(Twin) 5/73  
Sump Plug  
Models: TR7/T140  
Date: 6/6/73

### OIL LEAKAGE AT SUMP PLUG

### SUMP PLUG WITH 110<sup>th</sup> RING

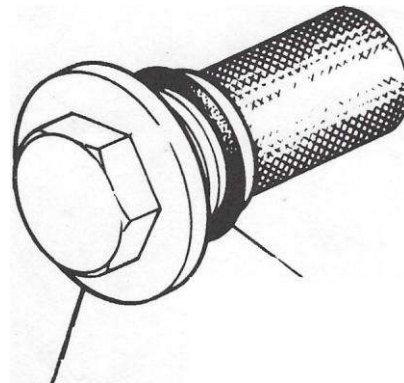
The sealing washer currently being used on the sump filter plug is sometimes prone to leakage.

Leakage at this point can easily be cured by fitting a "O" ring Part No. E-7310 in place of the flat washer. (This "O" ring is currently in use on the push rod tubes).

SUMP FILTER PLUG  
(E9336)

110<sup>th</sup> RING (E7310)
